July 11, 2024

RE: Stride S3 Line Project

Under the circumstances, after a detailed analysis of ST data and documents and in consultation with our community, we are now formally proposing the following alternative design concept for BAT transit improvement through Lake Forest Park (see attached).

DRAWING No.:
BT322-CMP210
 FACILITY ID:
BT322
 SHEET No.:
0738
 REV:

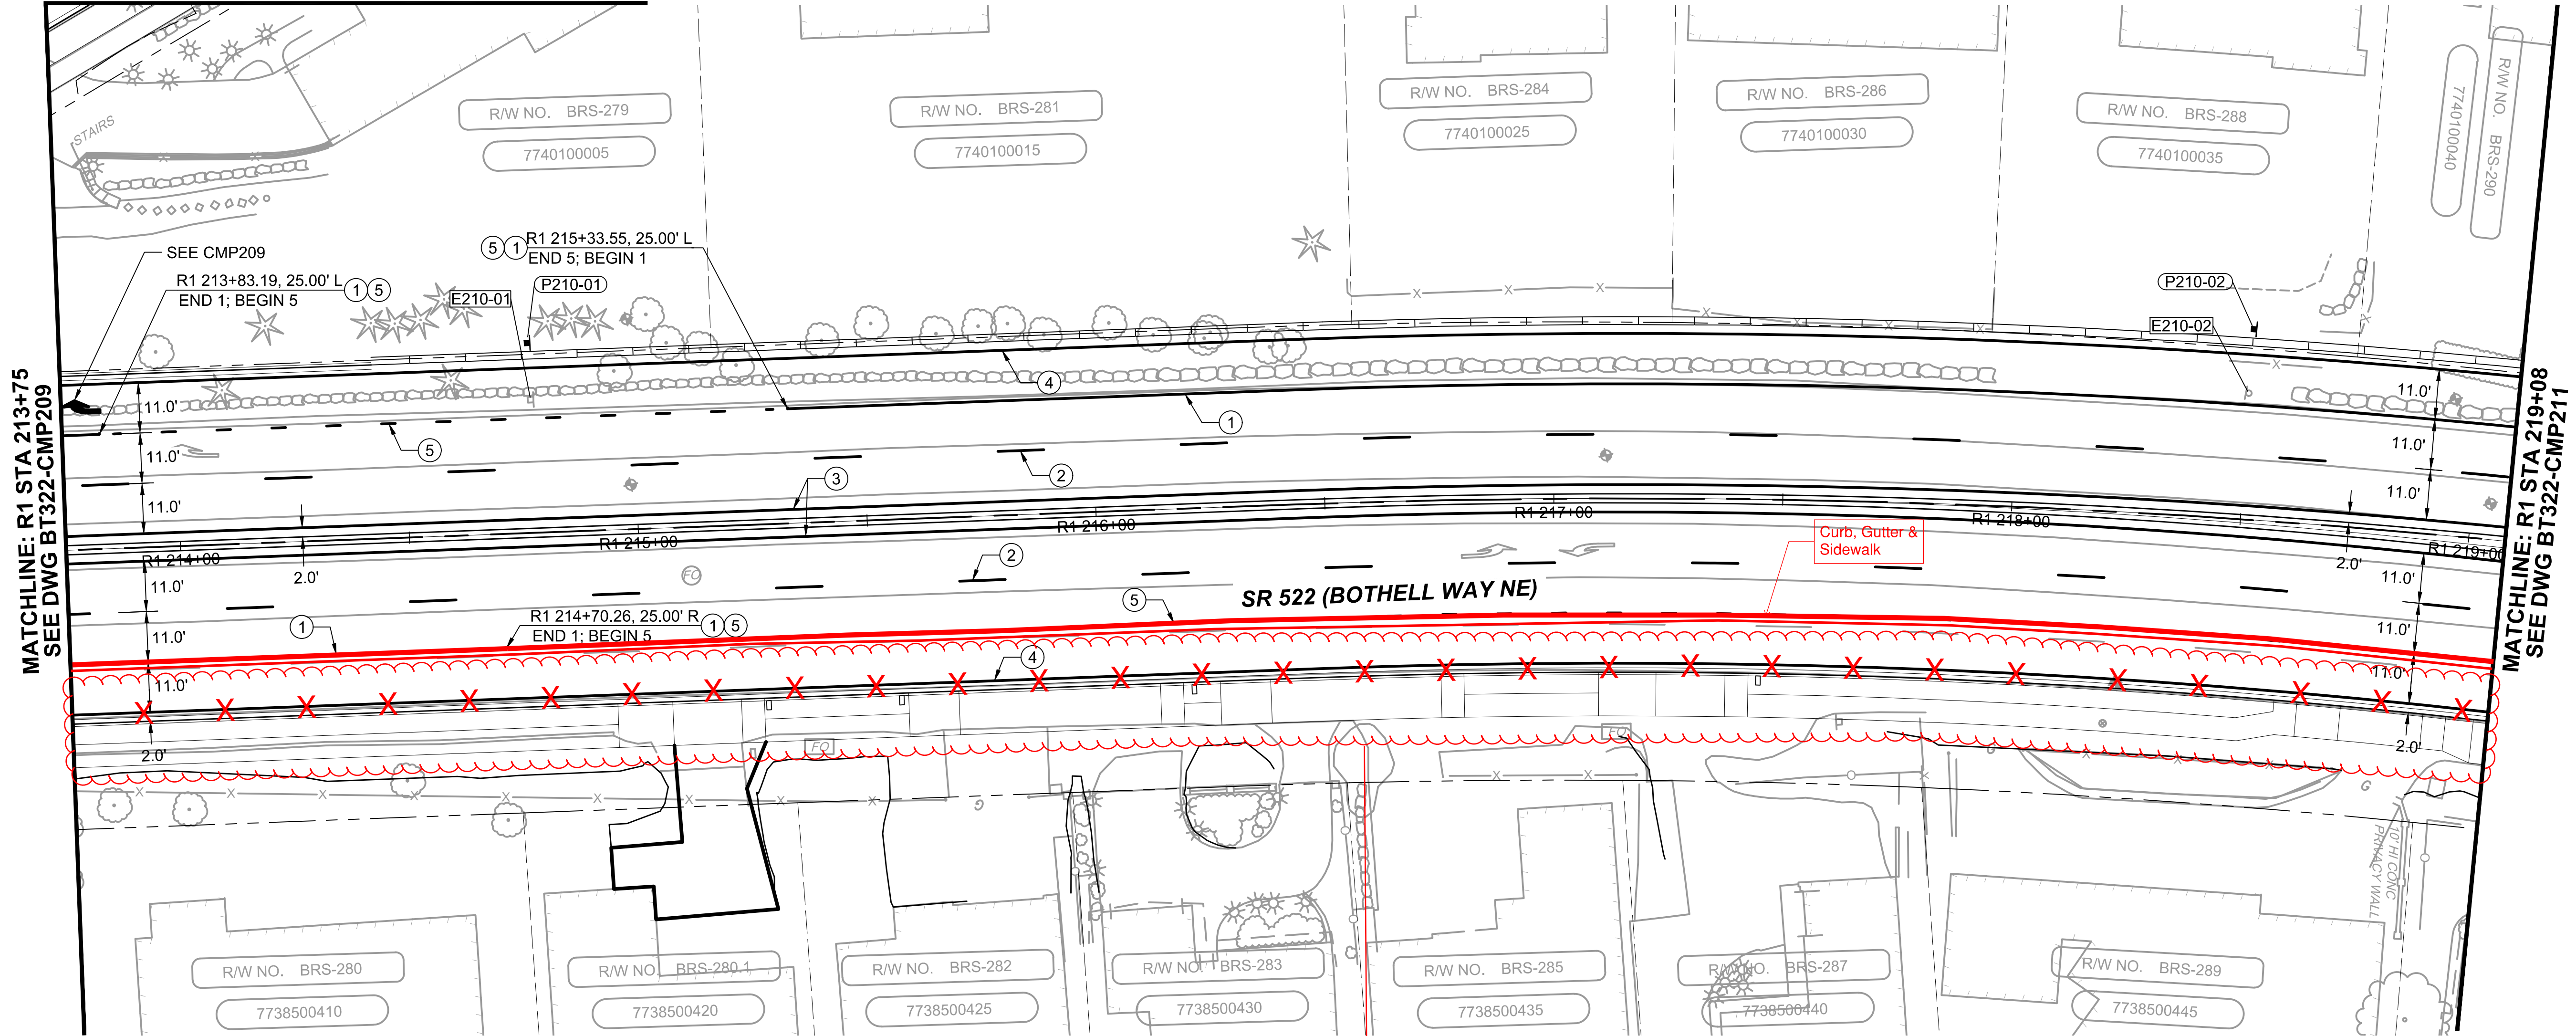
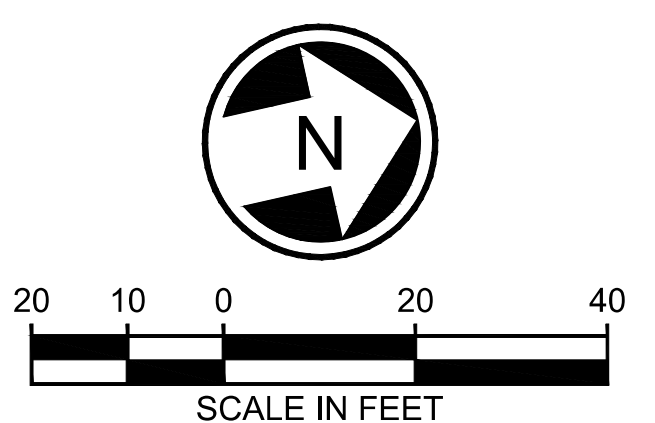
Shift sidewalk, curb, and edge of pavement improvements up to more closely align with existing roadway limits.

Suggested Modifications
 1. Revise roadway, curb, and sidewalk geometry to remove BAT lane to reduce ROW impacts and preserve mature vegetation as much as feasible.

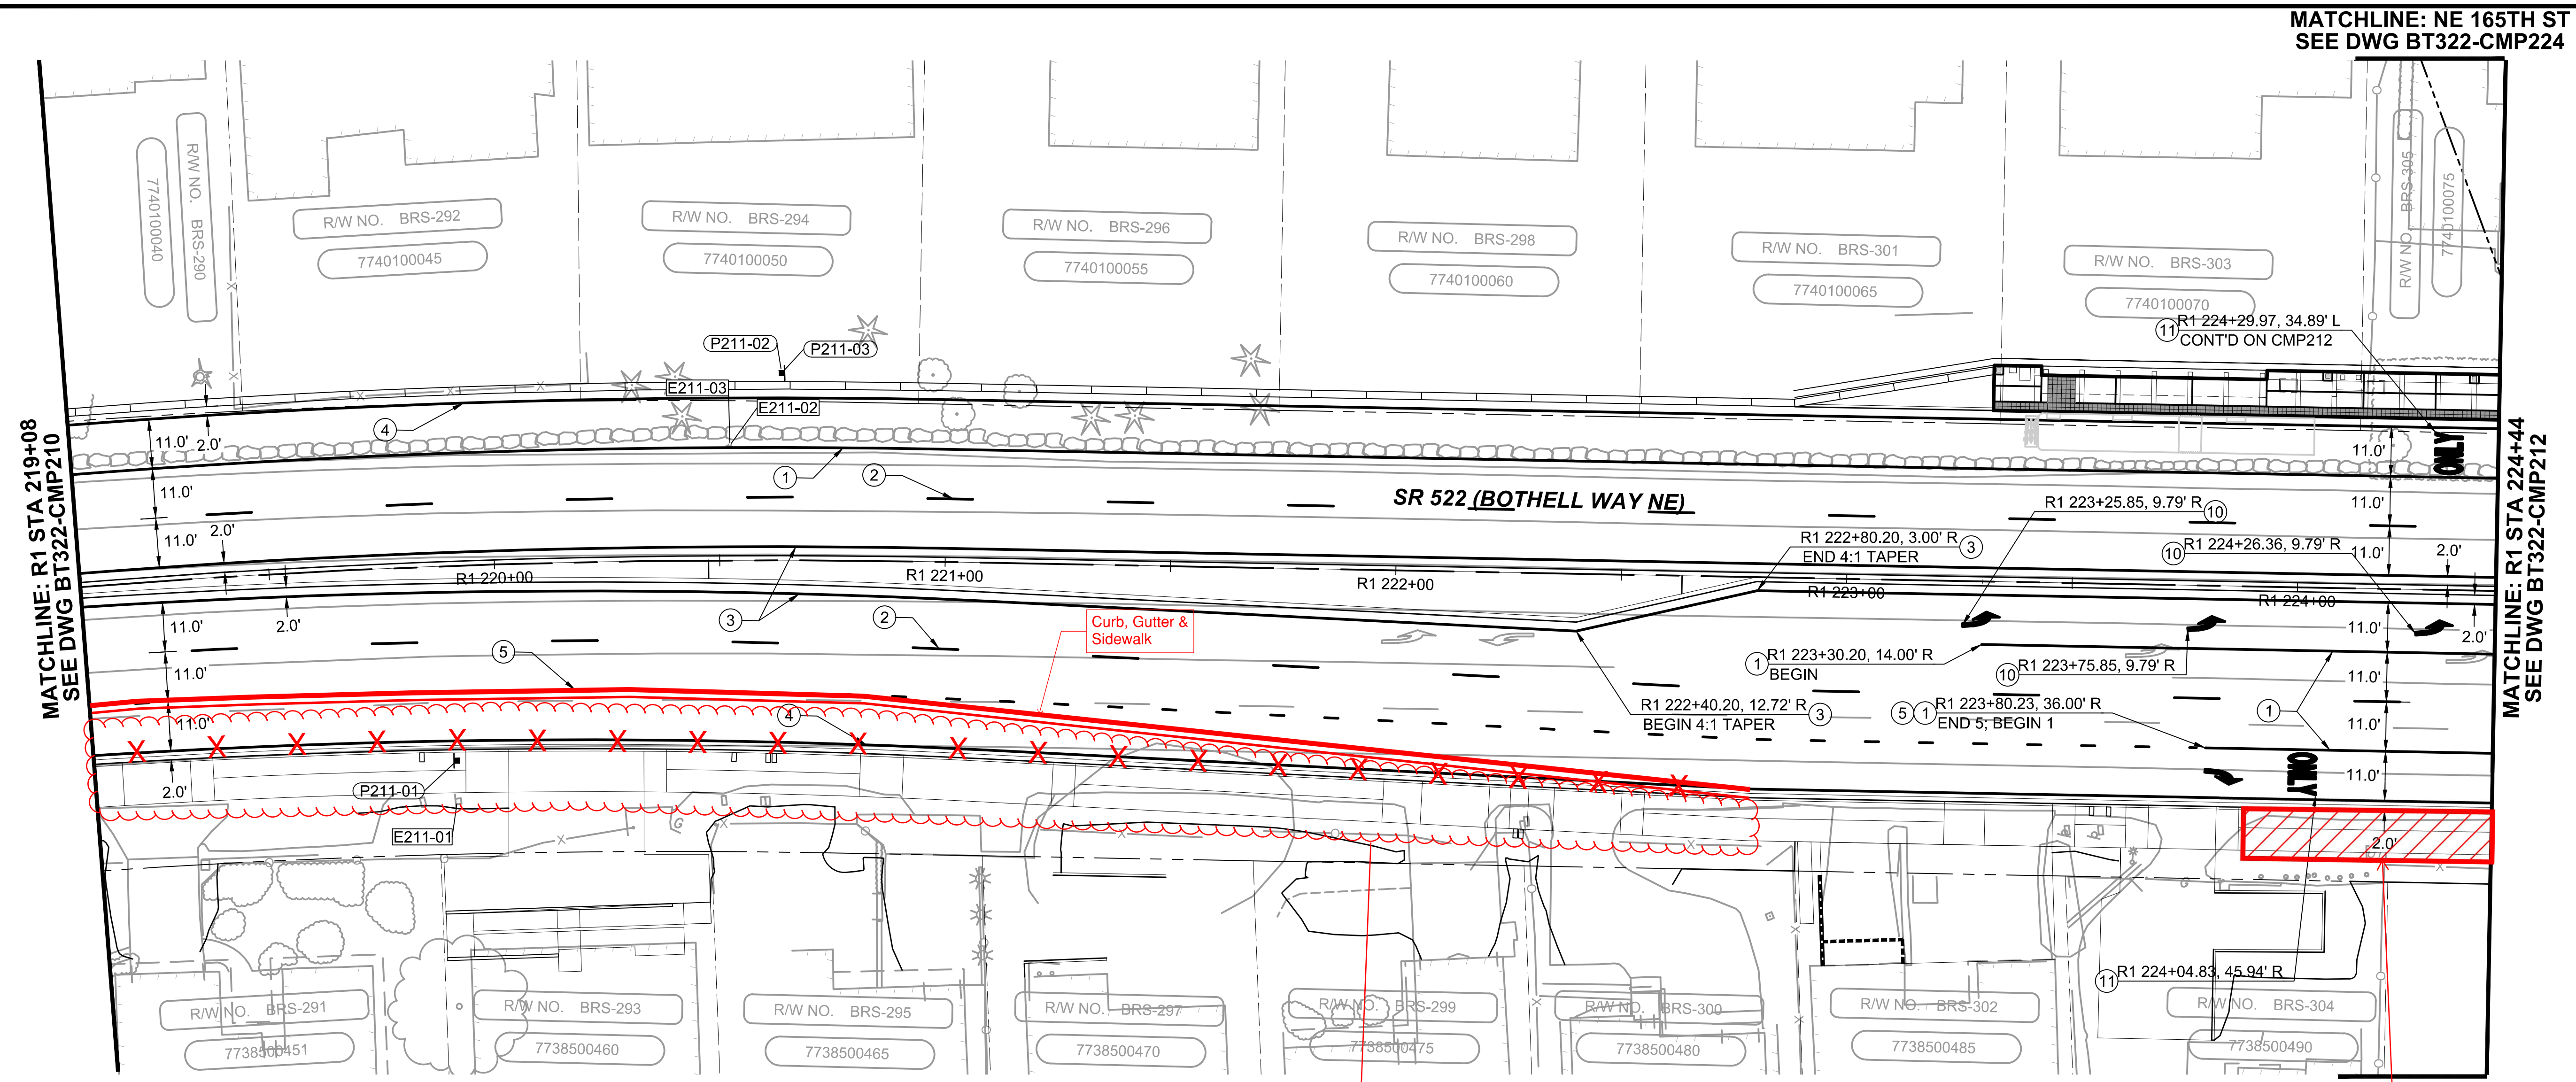
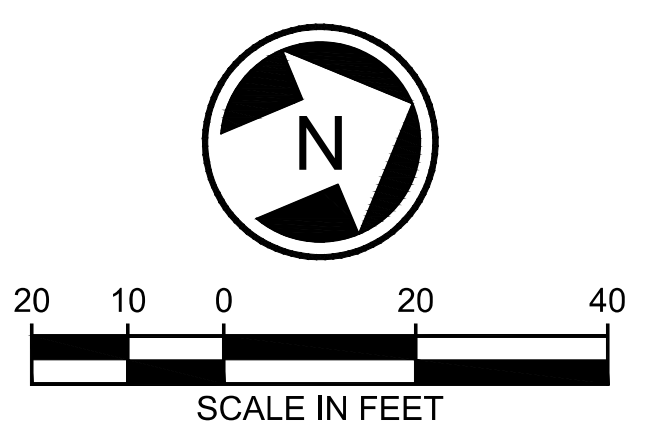
Shift sidewalk, curb, and edge of pavement improvements up to more closely align with existing roadway limits.

Relocate proposed bus station from opposite side of intersection.

Suggested Modifications
 1. Revise roadway, curb, and sidewalk geometry to remove BAT lane while maintaining right turn lane to reduce ROW impacts and preserve mature vegetation as much as feasible.

DRAWING No.:
BT322-CMP212
FACILITY ID:
BT322
SHEET No.:
0740
REV:

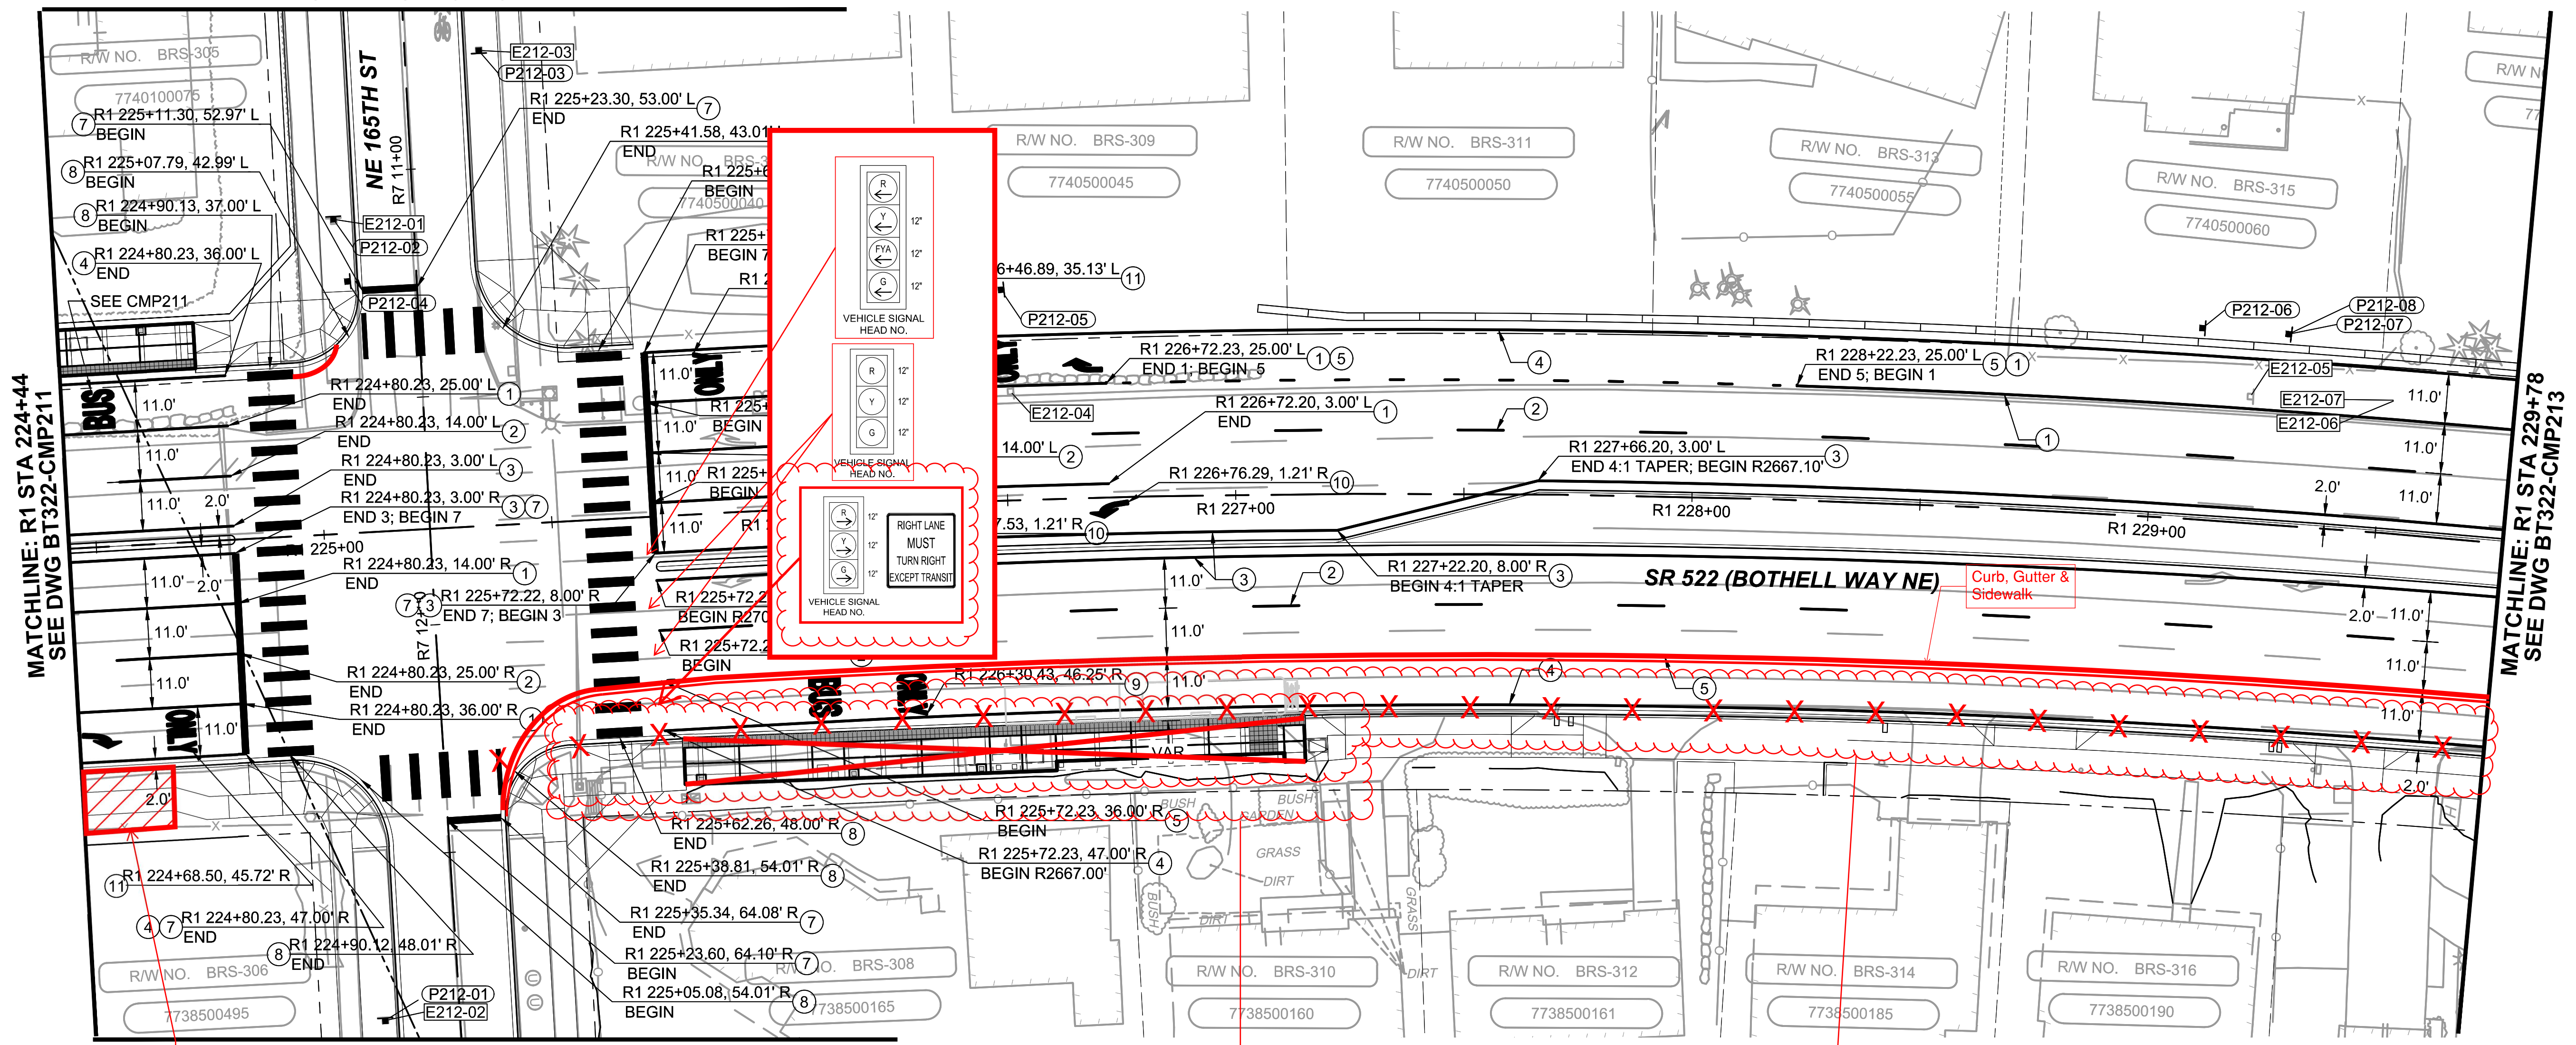
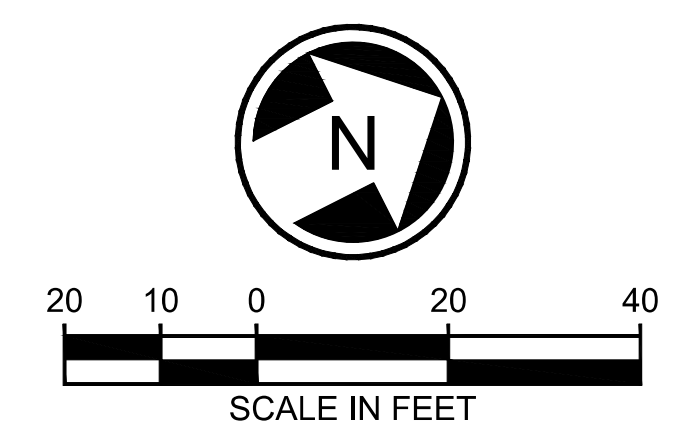
Relocate proposed bus station from opposite side of intersection.

Relocate bus station prior to NE 165th St intersection.

Shift sidewalk, curb, and edge of pavement improvements up to more closely align with existing roadway limits.

Suggested Modifications
 1. Relocate bus stop prior to intersection to improve traffic flow with removed BAT lane.
 2. Revise right turn lane signal to right arrows to allow for transit queue jump.
 3. Revise roadway, curb, and sidewalk geometry to remove BAT lane north of NE 165th St intersection
